SERVICE BULLETIN

Classification:	Reference:	Date
EC01-033	NTB02-020	February 18, 2002

1999-02 FRONTIER AND 2000-02 XTERRA KNOCKING NOISE ABOVE IDLE (800-1100 RPM)

APPLIED VEHICLES: 1999-2002 Frontier (D22) with VG33E - NOT Supercharged
2000-2002 Xterra (D22) with VG33E - NOT Supercharged

Figure 1

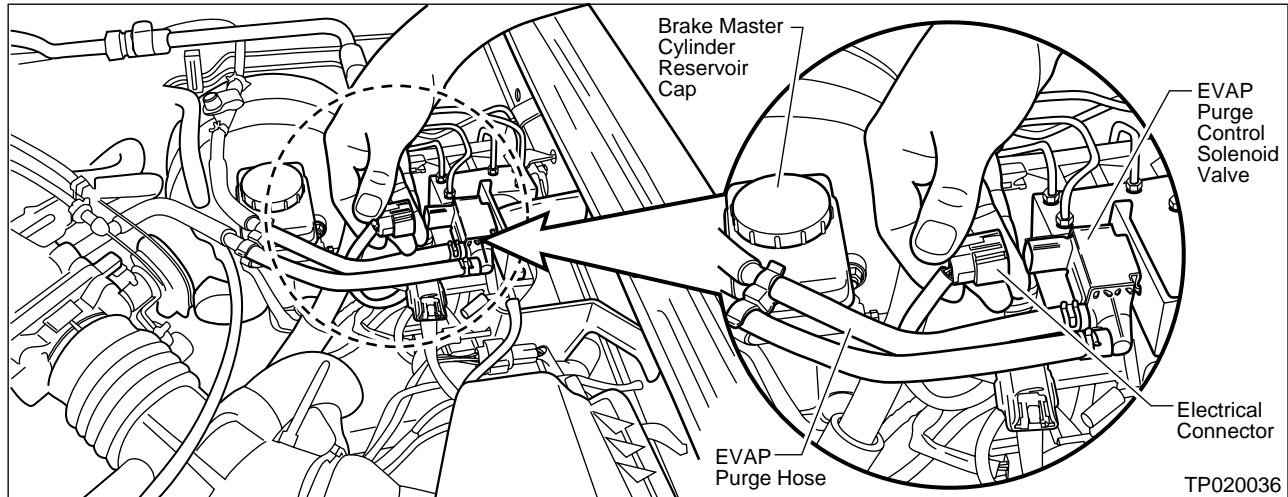
- 1) Put the transmission in "Neutral" (M/T) or "Park" (A/T).
- 2) Disconnect the electrical connector to the EVAP Purge Volume Control Solenoid Valve (see Figure 1).

8. Reconnect the electrical connector to the EVAP Purge Volume Control Solenoid Valve (see Figure 1, page 2).
9. Repeat steps 3, 4a, and 4b (on pages 1 and 2) to verify the slight “knocking” noise is gone.

Figure 2

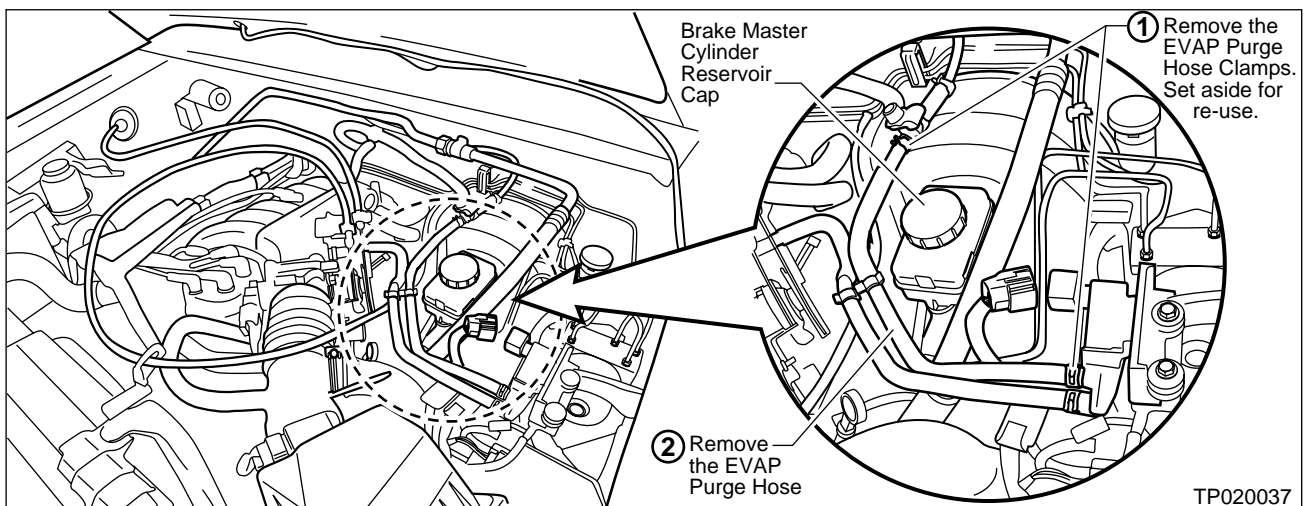
5. Remove the Hose Clamps from the EVAP Purge Hose (see Figure 2).

6. Remove the EVAP Purge Hose (see Figure 2).

Figure 3

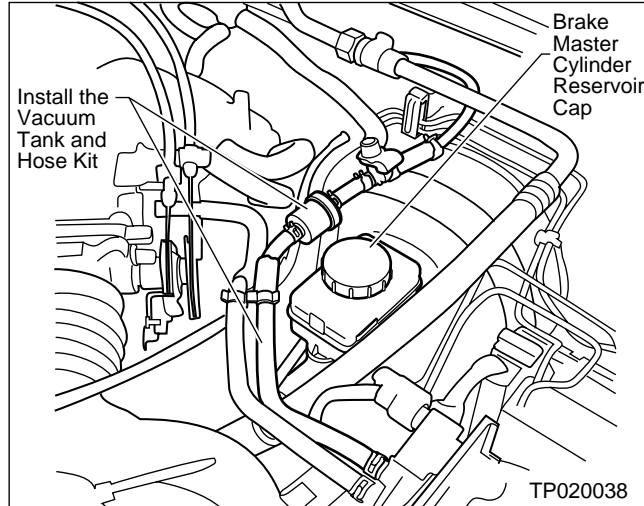
7. Install the Vacuum Tank and Hose Kit listed in the PARTS INFORMATION section (see Figure 3).

NOTE: Use the hose clamps set aside in step 6 to secure the replacement parts.
